FREDONIA PUBLIC WORKS COMMITTEE MEETING

DRAFT - OWNER REVIEW (2/16/2022)

Re: Phosphorus Optimization and Facility Evaluation
Village of Fredonia, WI

Phosphorus Optimization and Facility Evaluation

Figure 1

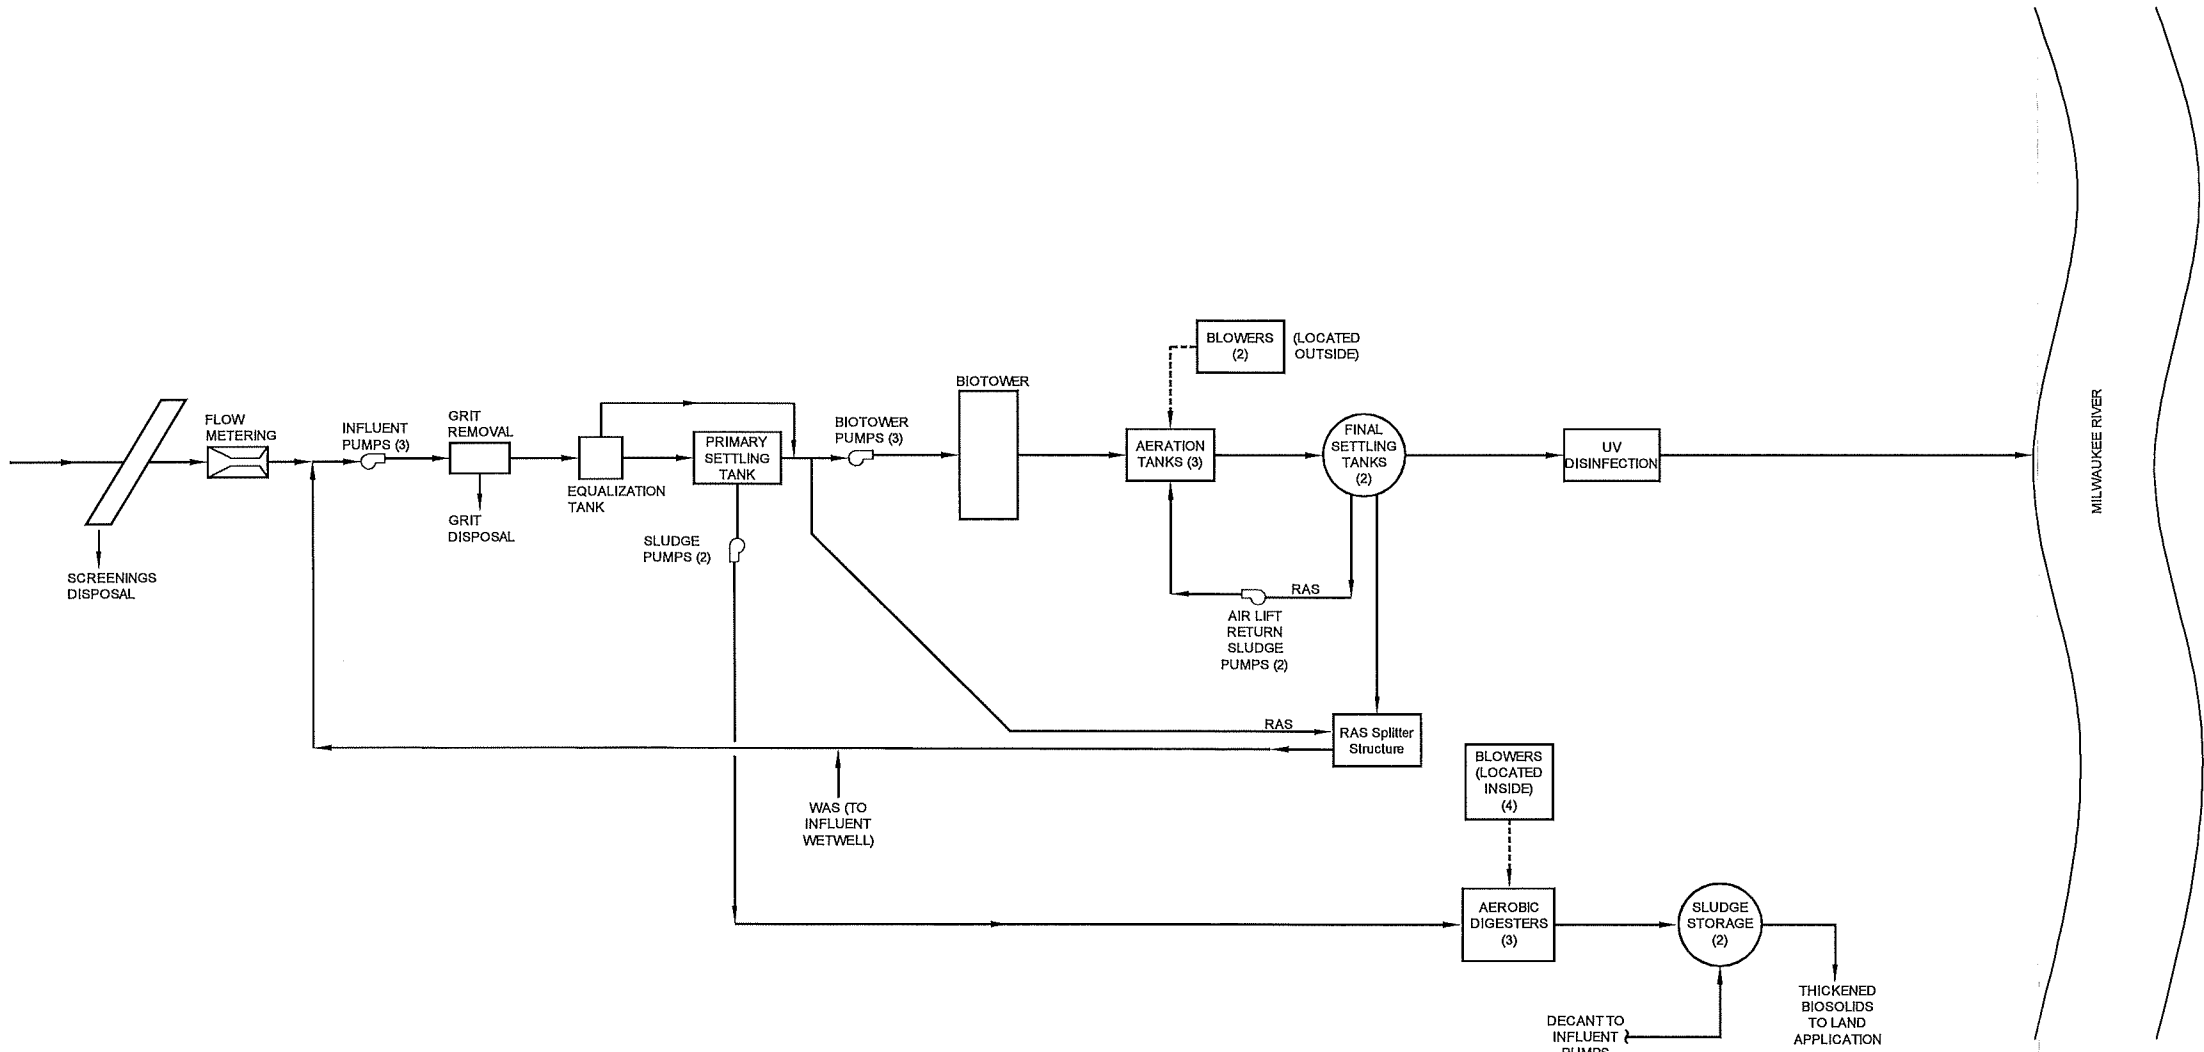
At best we adjust weekly

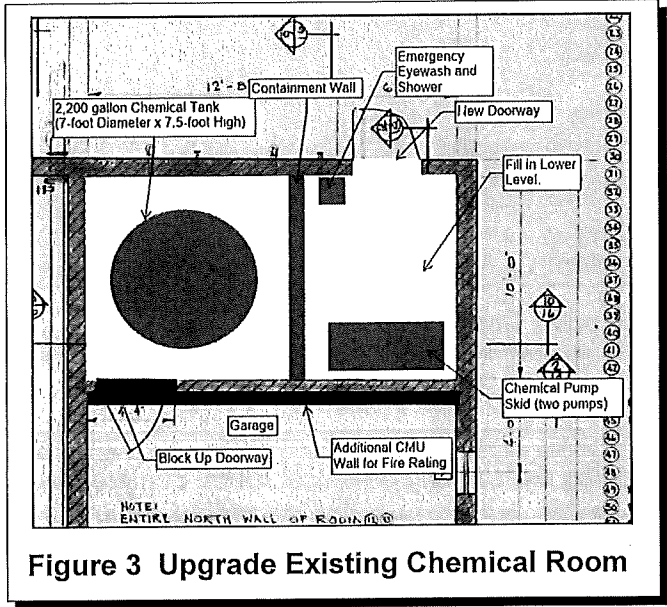
3 pumps one for lower dosage
